***PREFERRED PROJECT AND
RESPONSE TO SUBMISSIONS REPORT***

CROOKWELL 3 WIND FARM

March 2014

MAJOR PROJECT APPLICATION NUMBER (MP 10_0034)

HISTORY PLAN - C3 EAST
FIGURE 4

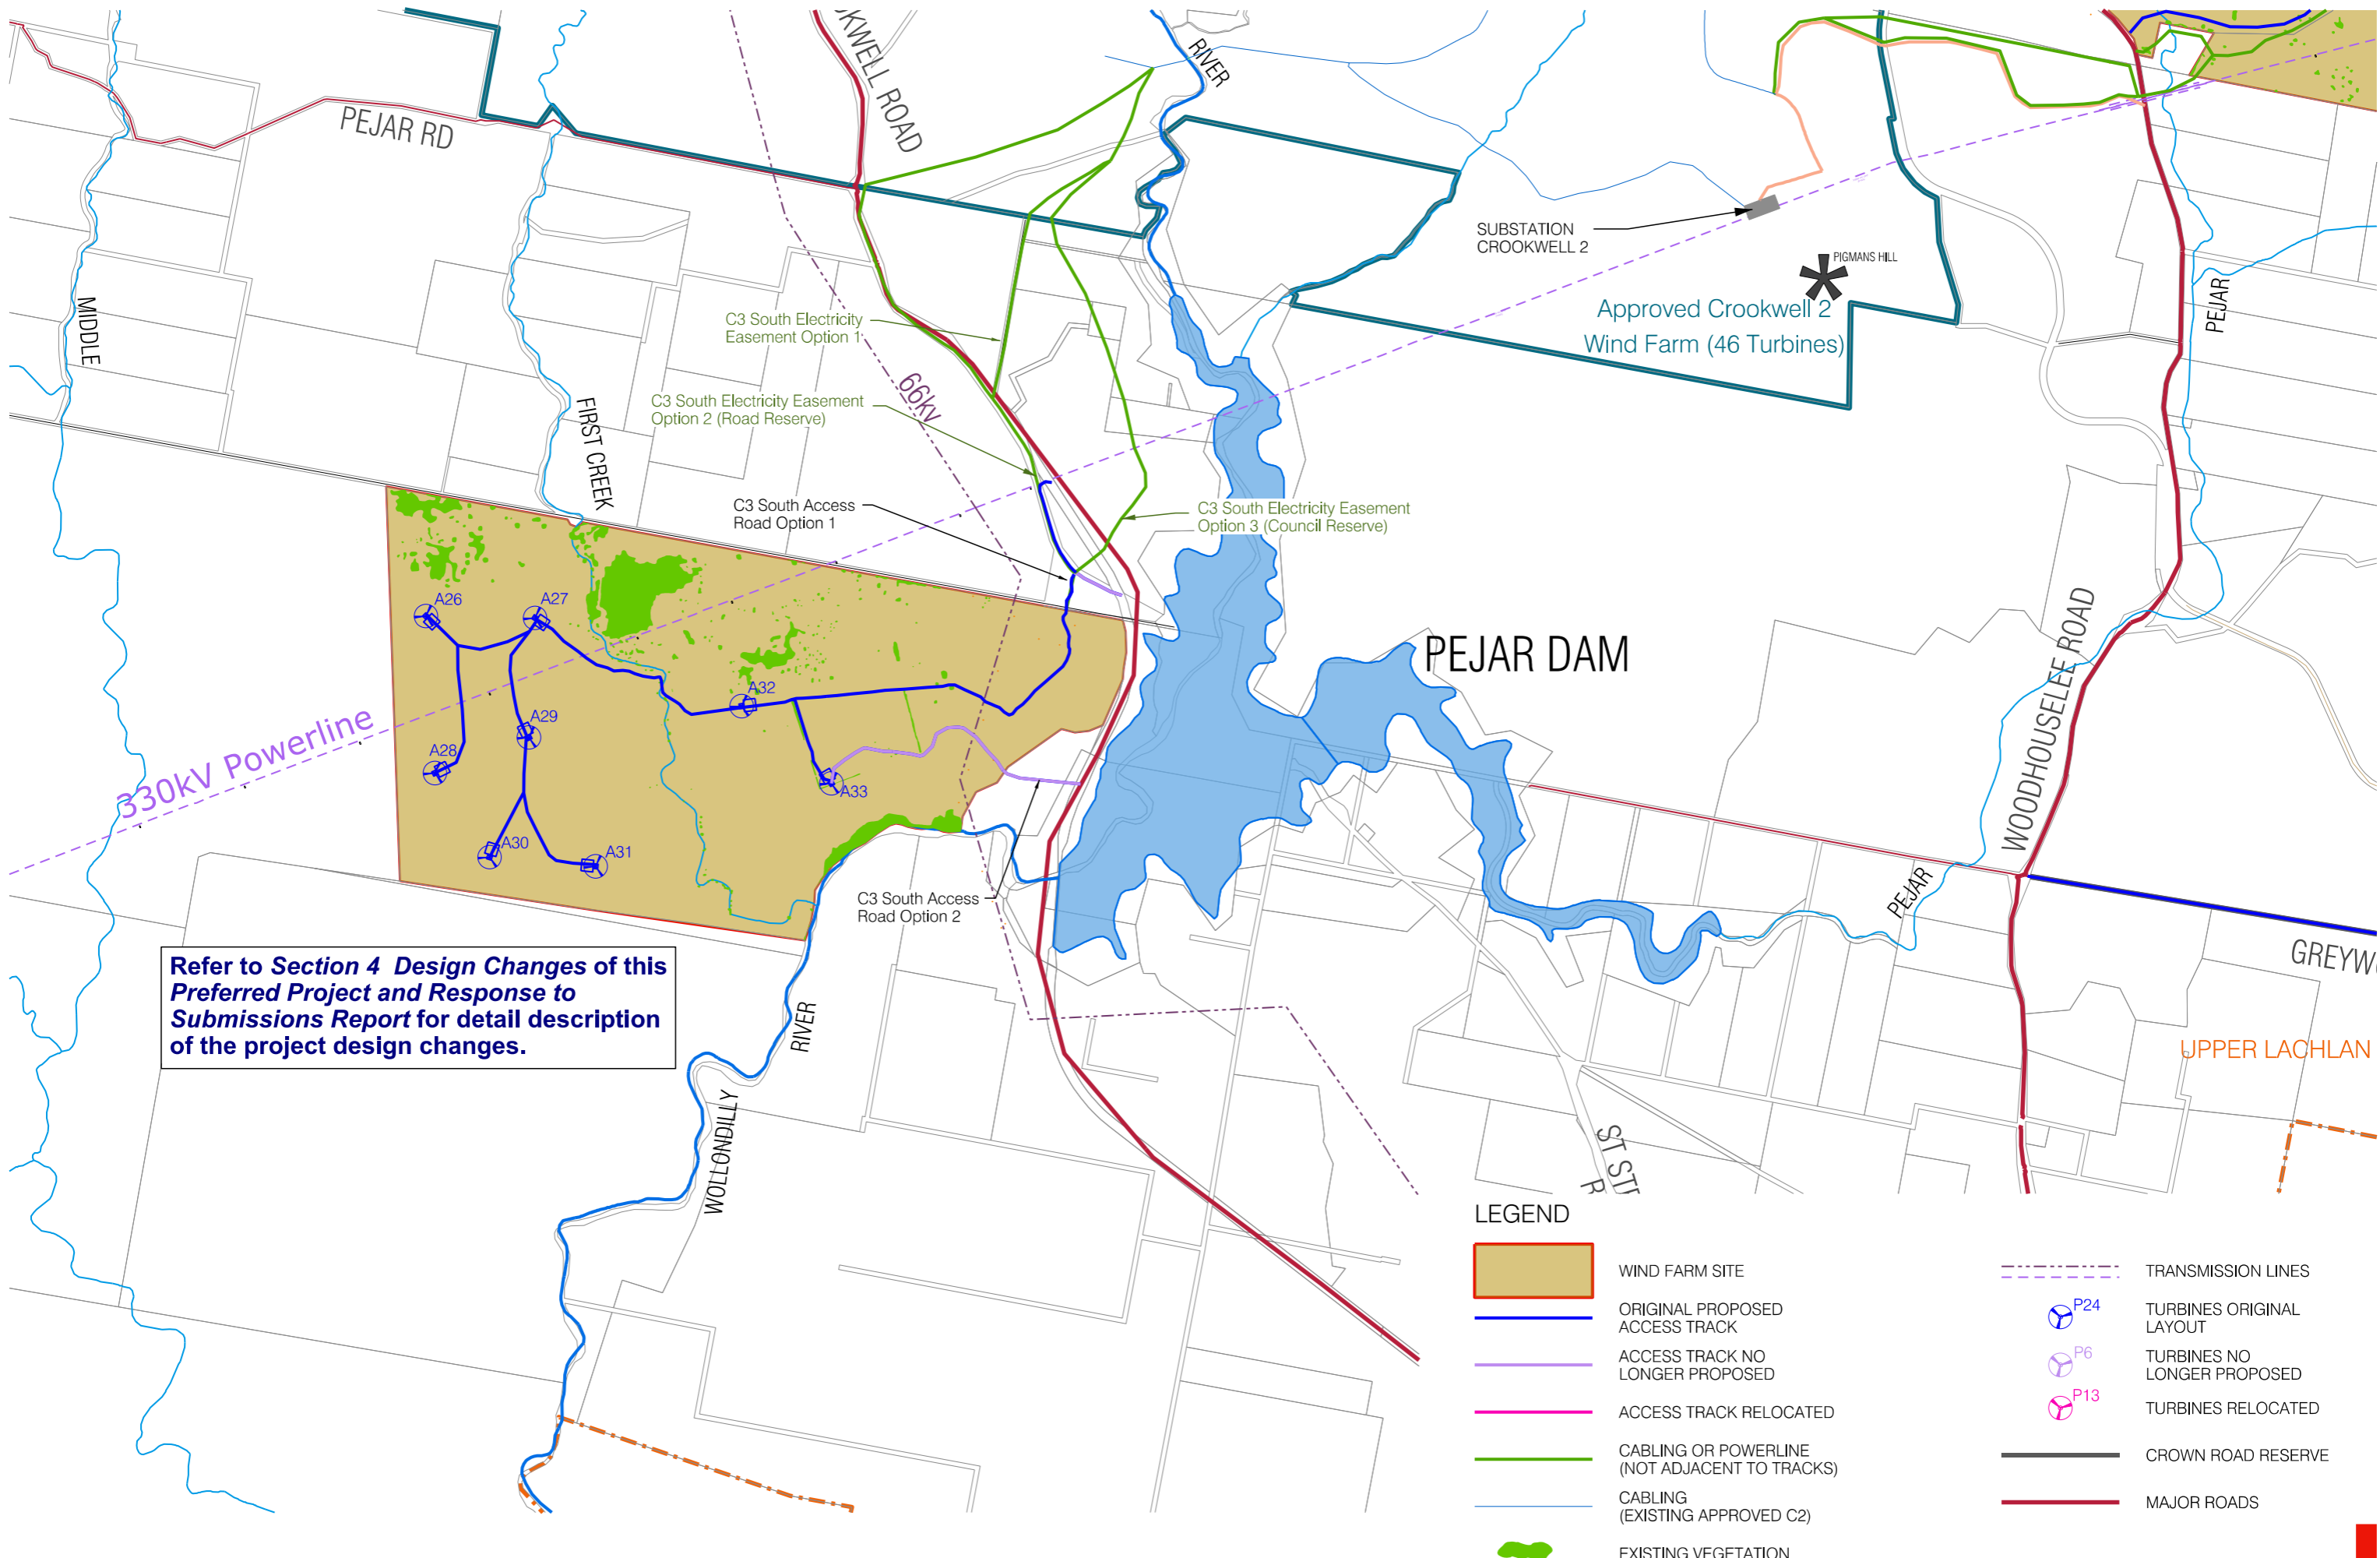
- removing turbine A19 from the publically exhibited layout as a precautionary measure so as to reduce potential impact to the remnant area by avoiding further fragmentation;

The project design changes are shown in *Figure 4 - History Plan - C3 East* and *Figure 5 - History Plan - C3 South*.
